NEW RESIDENCE

1385 HILLSIDE CIRCLE, (LOT 3) BURLINGAME, CA
A.P.N.: 000-000-000

RECEIVED August 27, 2025 City of Burlingame CDD-Planning DIV
			CONSTRUCTION SCHEDULE 1. NO PERSON SHALL ERECT (INCLUDING EXCAVATION AND GRADING), DEMOLISH, ALTER OR REPAIR ANY BUILDING OR STRUCTURE OTHER THAN BETWEEN THE FOLLOWING HOURS EXCEPT IN THE CASE OF URGENT NECESSITY IN THE INTEREST OF PUBLIC HEALTH AND SAFETY, AND THEN ONLY WITH PRIOR WRITTEN APPROVAL FROM THE BUILDING OFFICIAL, WHICH APPROVAL SHALL BE GRANTED FOR A PERIOD NOT TO EXCEED THREE DAYS. HOLIDAYS ARE THE FIRST DAY OF JANUARY, THE THIRD MONDAY OF FEBRUARY, THE LAST MONDAY OF MAY, THE FOURTH DAY OF JULY, THE FIRST MONDAY OF SEPTEMBER, THE ELEVENTH DAY OF NOVEMBER, THE FOURTH THURSDAY IN NOVEMBER AND THE TWENTY-FIFTH DAY OF DECEMBER. IF THE FIRST DAY OF JANUARY, THE FOURTH DAY OF JULY, THE ELEVENTH DAY OF NOVEMBER AND THE TWENTY-FIFTH DAY OF DECEMBER FALLS UPON A SUNDAY THE FOLLOWING MONDAY IS A HOLIDAY. PROVIDE THE FOLLOWING CONSTRUCTION HOURS ON THE PLANS PER CITY OF BURLINGAME MUNICIPAL CODE 18.07.110. i. MONDAY THROUGH FRIDAY: 8AM TO 7PM ii. SATURDAYS: 9AM TO 6PM iii. SUNDAY AND HOLIDAYS: NO WORK 2. CONSTRUCTION HOURS IN THE CITY

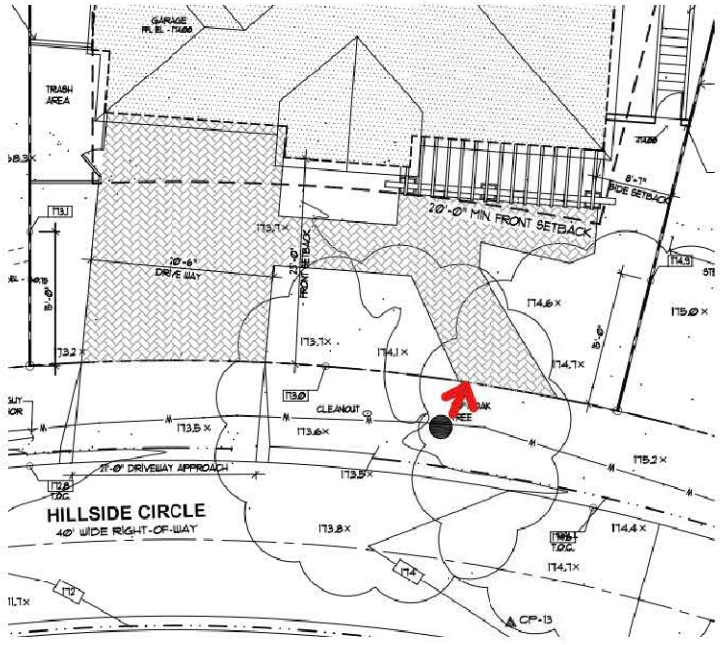
Plan change needed:
A new pathway is proposed at 4' from oak tree #10. This is too close to the tree and impacts would be expected. It is recommended to maintain a minimal clearance of 10' from the tree to the pathway to keep impacts on the tree low. With this plan change implemented, impacts are expected to be minor and will be mitigated by the recommended deep water fertilizing with Nutriroot.

A new pathway is shown adjacent to valley oak tree #2. It is recommended to have the pathway no closer to the tree than the existing pathway next to the tree. This may result in a plan change. All landscaping work below the dripline of the tree is recommended to be done by hand under the direct supervision of the project arborist. Excavation is recommended not to exceed 6" for any landscaping when underneath the tree's dripline. No roots measuring larger than 1.5" in diameter shall be cut for landscaping purposes. No grading shall also take place underneath the tree's dripline.

SITE DEMOLITION PLAN
SCALE: 3/32"=1'-0"

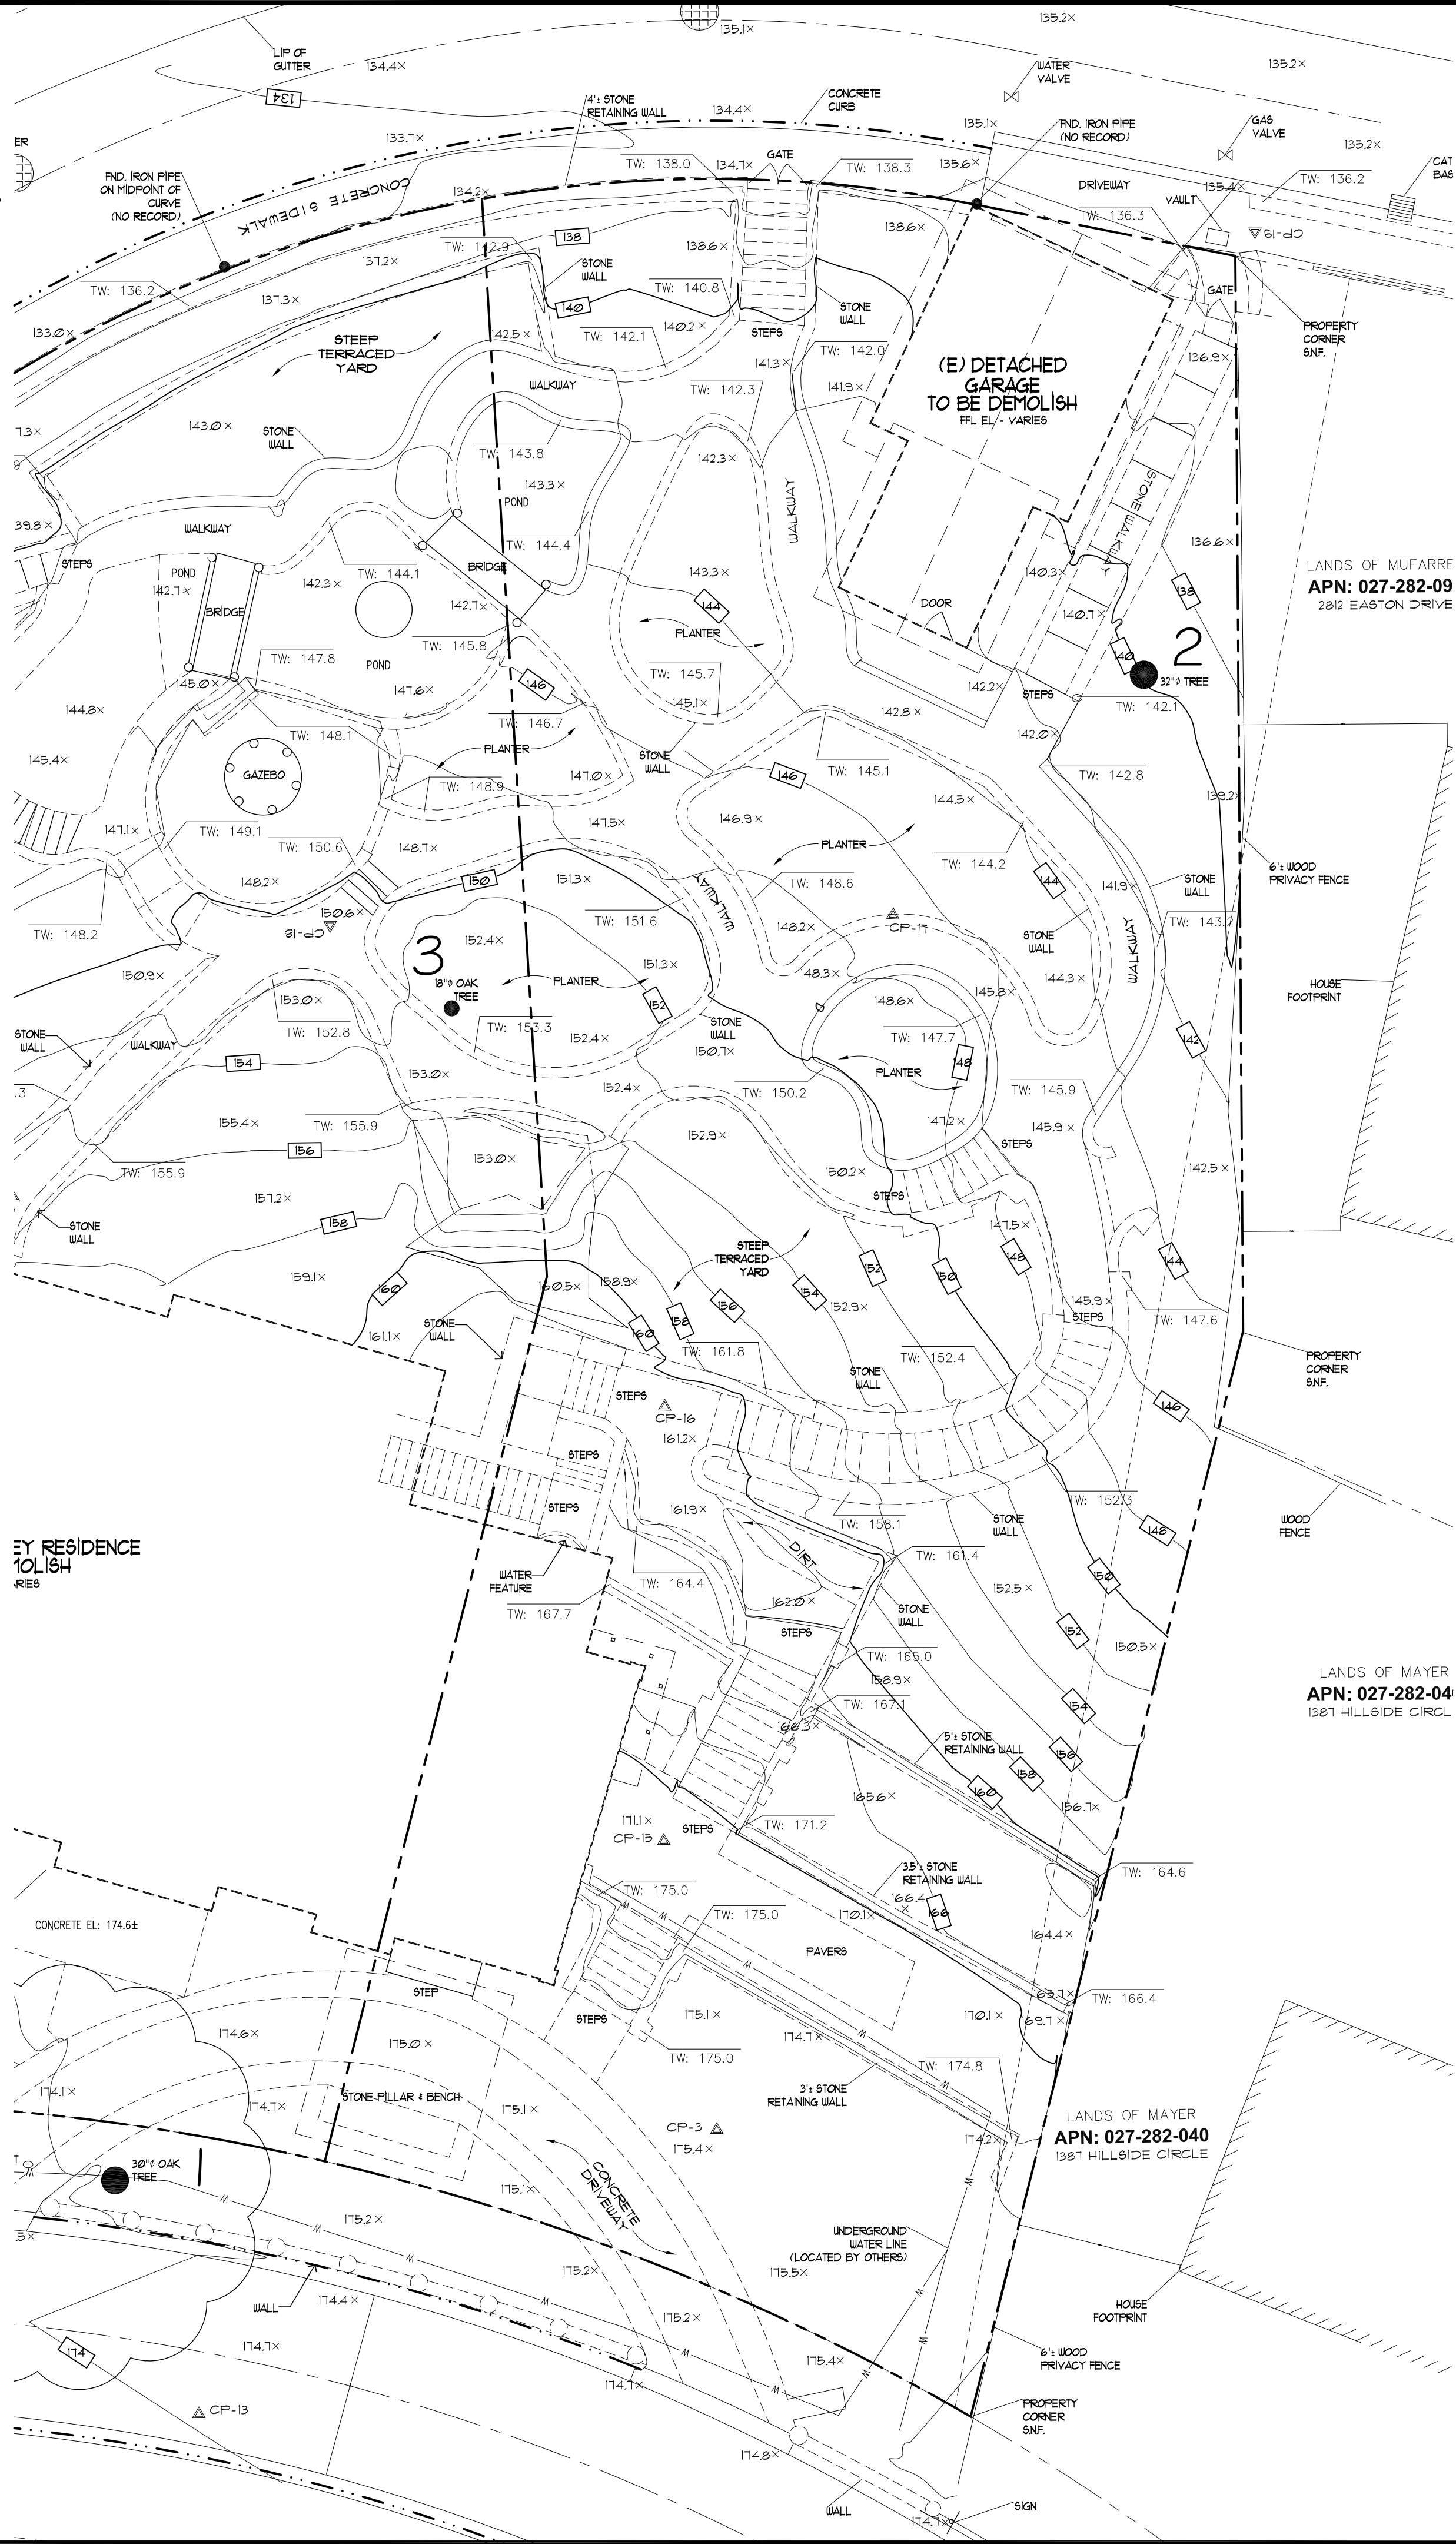
ENSURE THAT TREE PROTECTION SPECIFICATIONS ARE SHOWN GRAPHICALLY ON SITE PLANS FOR CONTRACTOR TO FOLLOW, AS FOLLOWS:

LOCATION OF ALL TREE PROTECTION MEASURES INCLUDING BUT NOT LIMITED TO FENCING, TRUNK WRAP, ROOT BUFFER, ARE TO BE GRAPHICALLY SHOWN ON DEMO PLAN A2 SO THAT CONTRACTOR CAN EASILY INSTALL AND EXECUTE THE TREE PROTECTION MEASURES.

LOCATIONS OF HAND DIGGING AND LOCATIONS OF WORK TO BE UNDER PROJECT ARBORIST SUPERVISION ARE TO BE GRAPHICALLY SHOWN ON THE RELEVANT SITE PLAN SO THAT CONTRACTOR(S) CAN EASILY UNDERSTAND AND EXECUTE THE SPECIFICATIONS. WORK WITH THE PROJECT ARBORIST TO PRODUCE ACCURATE INFORMATION ON THE RELEVANT SITE PLAN. SOME OF THE INFORMATION WILL BE ON THE A SHEETS AND SOME ON THE L SHEETS.

ARBORIST REPORT RECOMMENDS:
RETAINING SOME OF THE DRIVEWAY NEAR TREE 1 AND BREAKING IT DOWN BY HAND LATER IN THE PROJECT. PUT THIS ON DEMO PLAN A2 SO CONTRACTOR CAN FOLLOW IT.
CHANGING THE PATHWAY NEAR TREE 10 TO AVOID ROOT LOSS/DAMAGE. WHERE IS TREE 10? HAS THE PATHWAY BEEN CHANGED?

ARBORIST REPORT IS BASED ON REVIEWING L PLANS DATED JAN 2024, LOT 1 A PLANS DATED 10-26-22, LOT 2 A PLANS DATED 10-26-21 AND LOT 3 A PLANS DATED 10-26-21. NO CIVIL PLANS REVIEWED. NOTE THAT THE CONTENT OF CIVIL PLANS MAY NECESSITATE A CHANGE IN THE ARBORIST RECOMMENDATIONS.

INDICATE THAT AT LEAST 3 SINGLE-TRUNKED LANDSCAPE TREES WILL BE PRESENT ON EACH LOT, AS NOTED BELOW.
PER CHAPTER 11.06, THIS PROJECT REQUIRES 3 SINGLE-TRUNKED LANDSCAPE TREES FOR LOT 3.
TREES MAY BE EXISTING OR NEW.
REQUIRED TREES MAY NOT BE FRUIT OR NUT TREES, PALMS, ITALIAN CYPRESS OR JAPANESE MAPLE.
REQUIRED TREES MUST HAVE A MATURE HEIGHT OF OVER 15 FEET.
ALL REQUIRED TREES MUST BE IN GOOD CONDITION AT THE FINAL ARBORIST INSPECTION.
STREET TREES DO NOT COUNT TOWARDS THE REQUIRED TOTAL.

PROVIDE THE BOTANICAL NAME (GENUS AND SPECIES) AND LOCATION OF THE REQUIRED LANDSCAPE TREES, AND WHETHER THEY ARE EXISTING OR NEW, FOR EACH LOT.
